DORRINGTON AVENUE

REVISIONS: PLANNING APPROVAL 08-10-17 CITY RESUBMITTAL 2 11-05-17 CITY RESUBMITTAL /3 \ 12-07-17

A-1.0

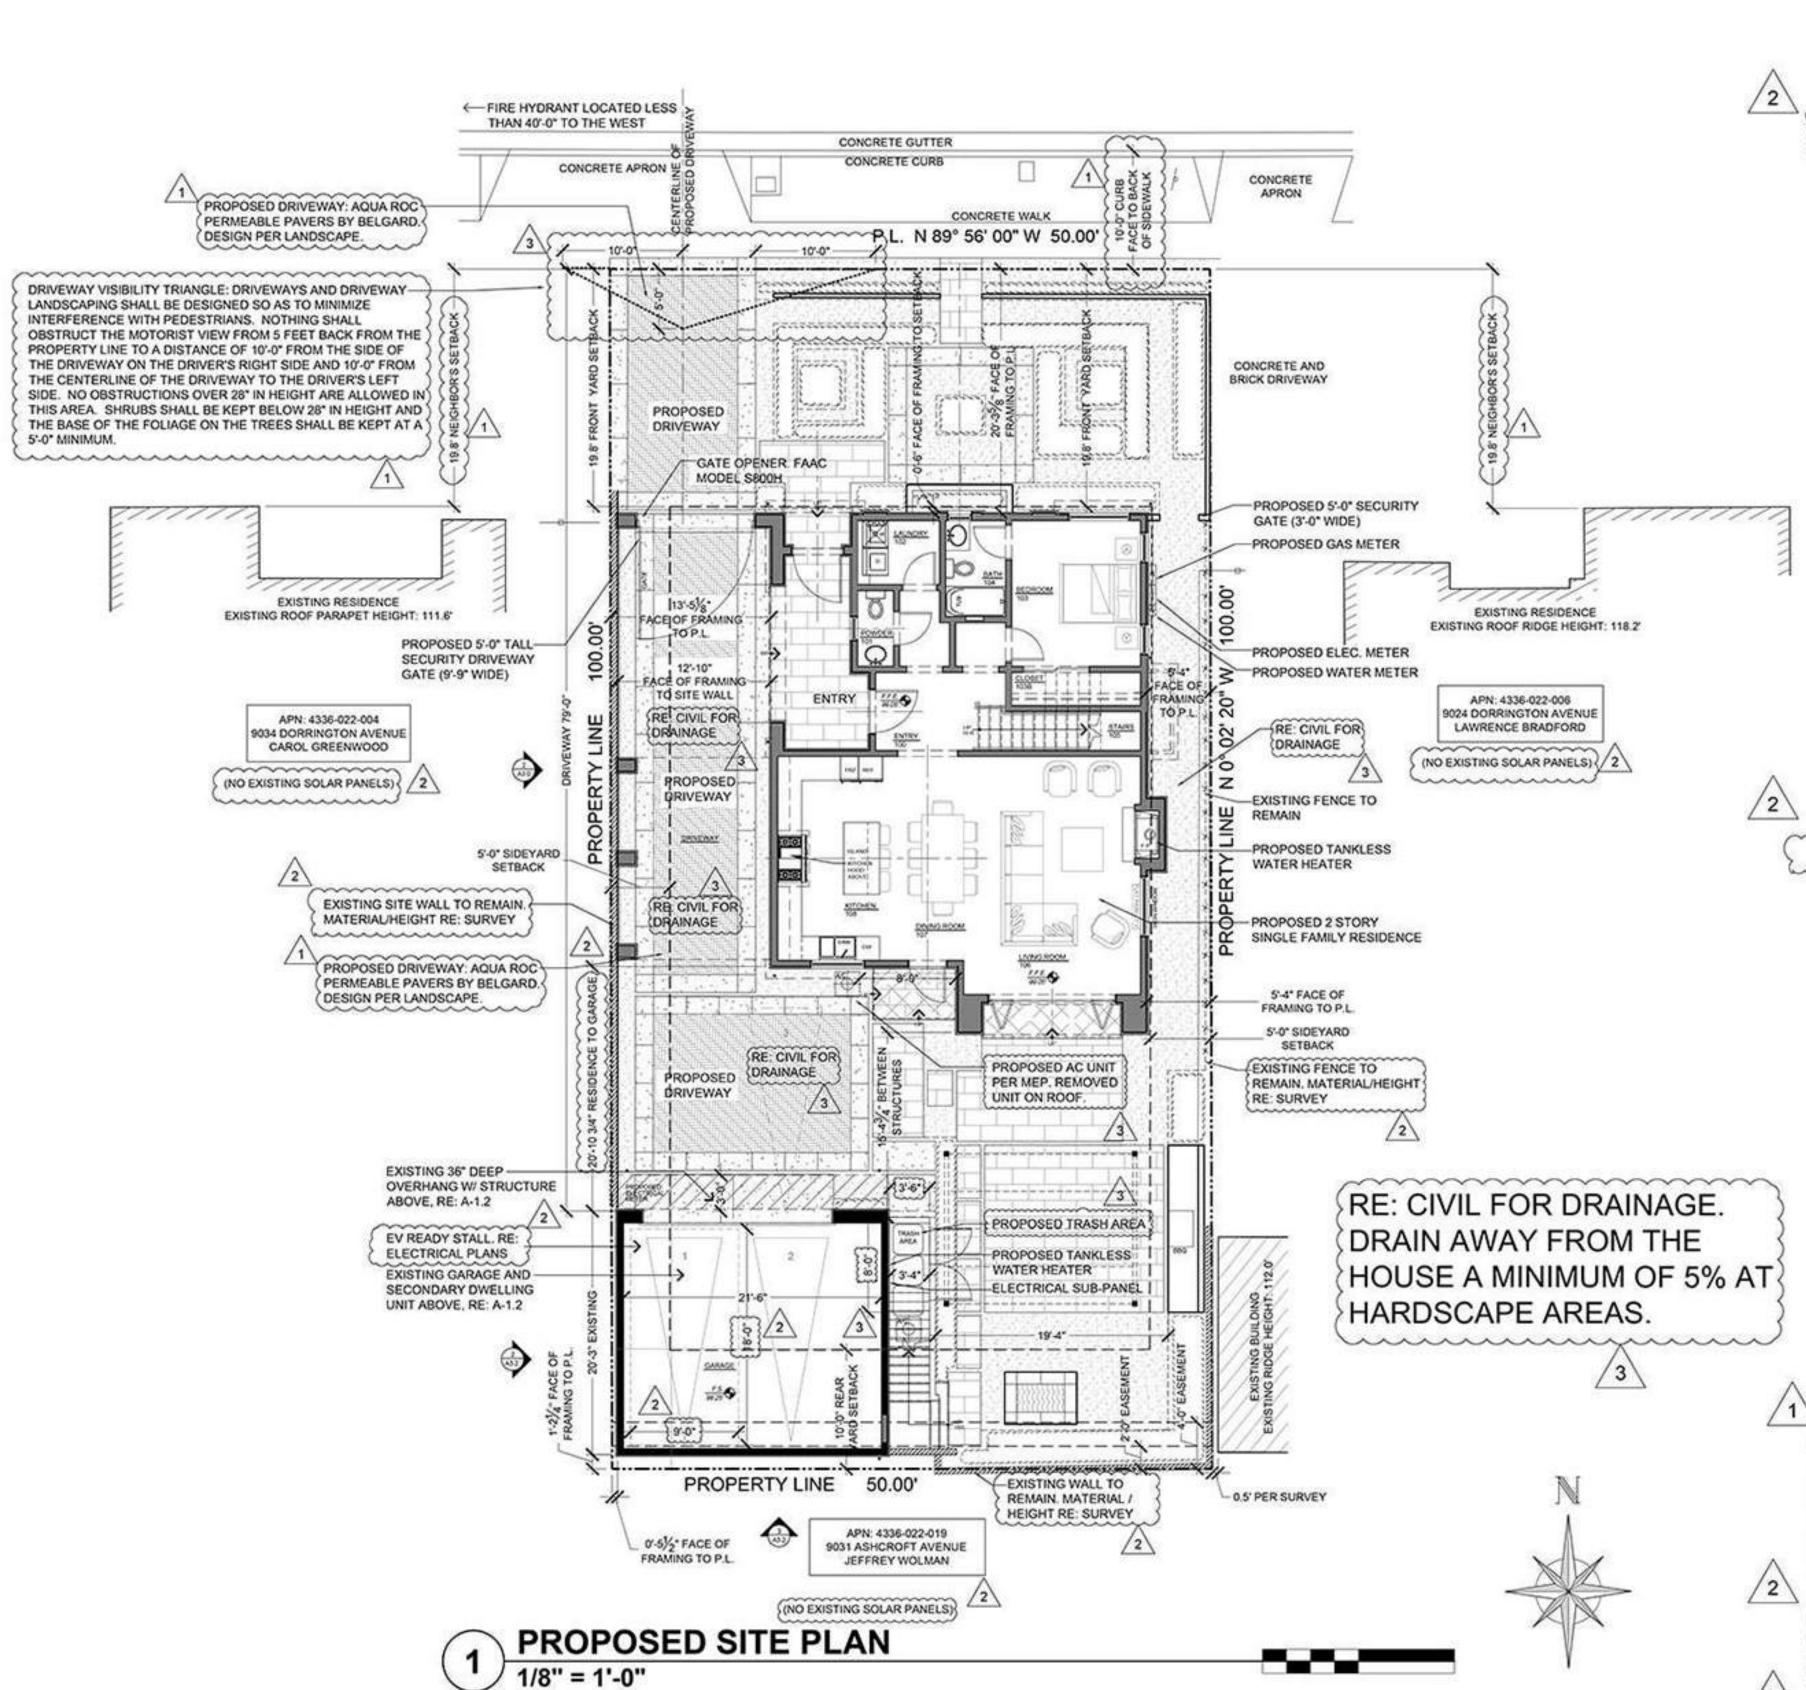
2. MINIMIZE EQUIPMENT, METERS AND VENTS VISIBLE ON THE EXTERIOR.

3. GUTTERS AND DOWNSPOUTS SHOWN SHOULD BE DECORATIVE.

4. PROVIDE LOCATION AND SCREENING OF HVAC EQUIPMENT

______ SOILS REPORT REQUIRES THE FOLLOWING: 40. 5% SLOPE AWAY FROM THE NEW RESIDENCE FOR THE FIRST 5 FEET

41. 2% HARDSCAPE SLOPE AWAY FROM THE RESIDENCE FOR THE FIRST 5 FEET 42. REVISE PLANS AND PROVIDE A SITE DRAINAGE SYSTEM. RE: CIVIL DRAWINGS 43. REVISE PLANS AND CONNECT ALL ROOF DOWN SPOUTS TO THE DRAINAGE SYSTEM RE: CIVIL DRAWINGS
